OPEN MEETING AGENDA ITEM
Arizona Department of Transportation

RE: Traffic Signal Preemption Timing
Docket RR-02635B-11-0282

Assessment of Interconnected Highway-Rail Grade Crossing Report March 12, 2012

AZ, Glendale
SR 303L @ Olive Ave
DOT # 025650G
Ennis Subdivision

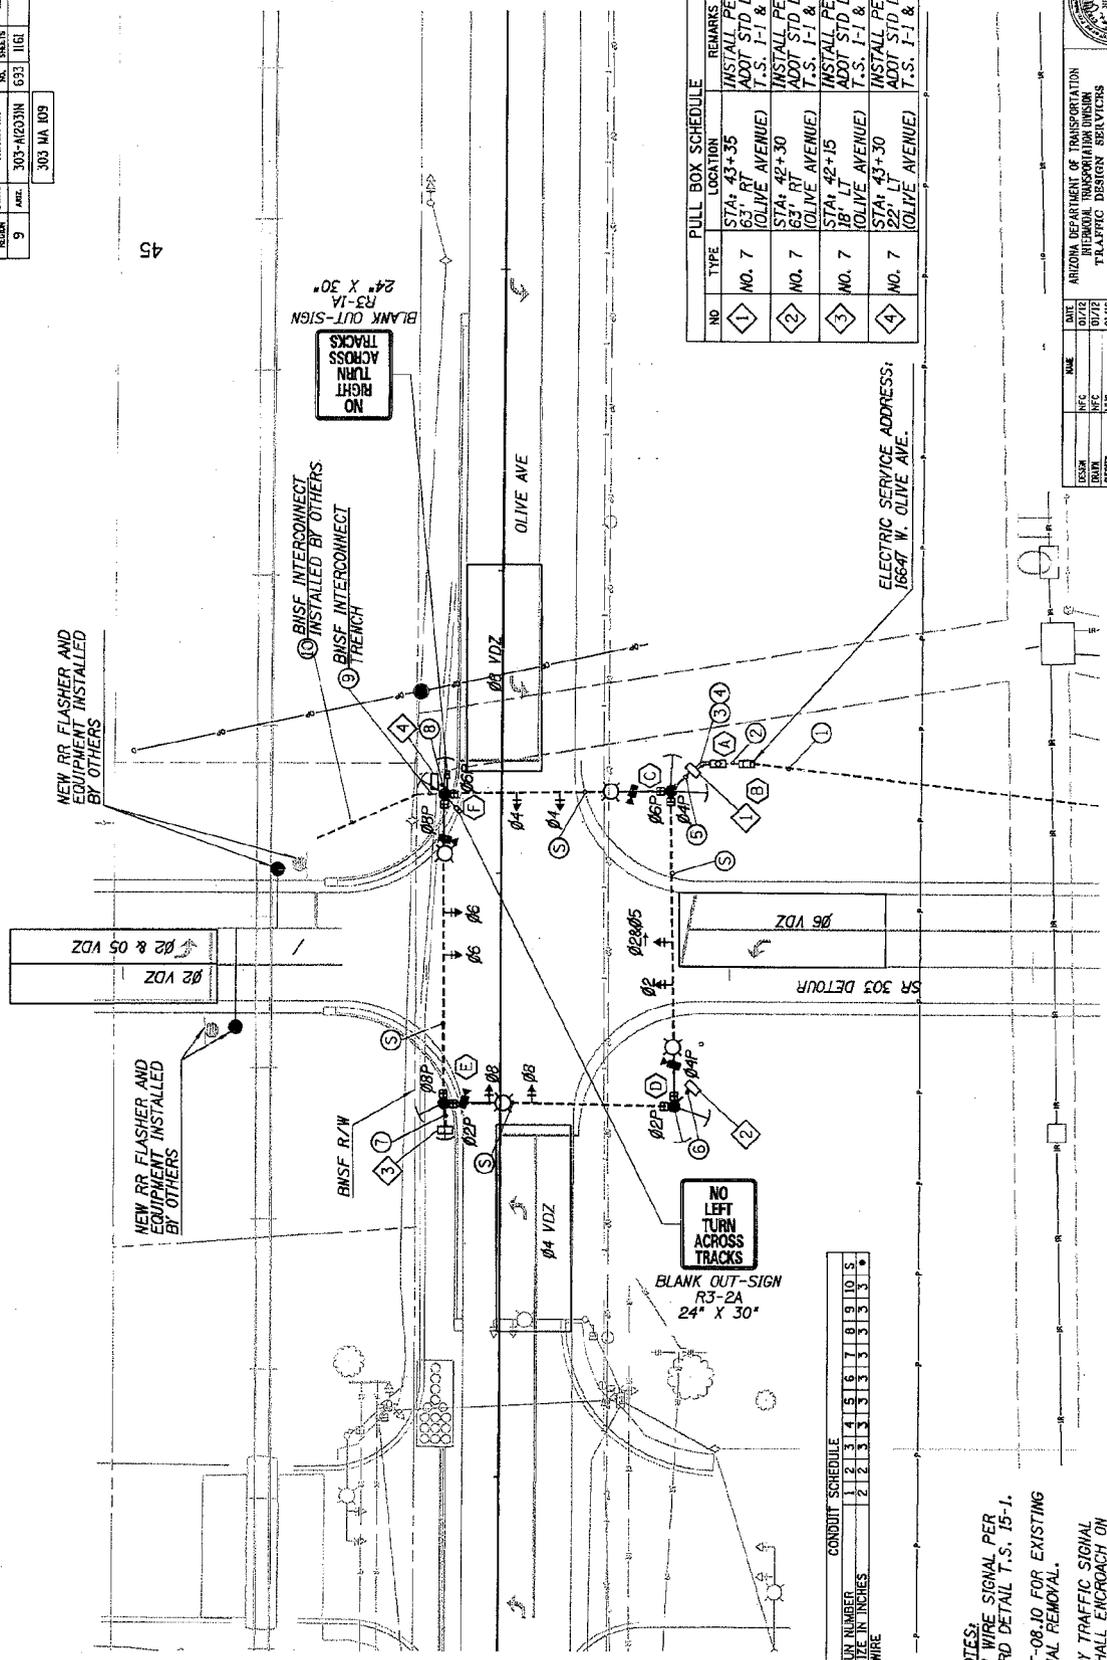
BNSF	5	Revised Pre-emption Request	Implement a left turn phase with a protected left turn indication for the track clearance green phase for SB 303L. This left turn indication does not need to be served at any time other than when pre-empted if desired	A	A left-turn phase will be included for the southbound direction with a 4-section type "G" signal head on the plans.	A	MGerber	Baker			
BNSF	6	Revised Pre-emption Request	Where the clear storage distance is less than the design vehicle length, vehicle detection should be considered upstream of the crossing so that longer vehicles can stop prior to the crossing while still placing a call to the traffic signal controller.	A	Video Detection is included at this intersection.	A	MGerber	Baker			
BNSF	7	Revised Pre-emption Request	Install "DO NOT STOP ON TRACKS" signs at the crossing.	A	Signs are already included on the plans.	A	MGerber	Baker			
BNSF	8	Revised Pre-emption Request	Change interconnection to double break or supervised operation.	A	The relay for supervised operation will be provided by ADOT. A note in the specs will be included	A	MGerber	Baker
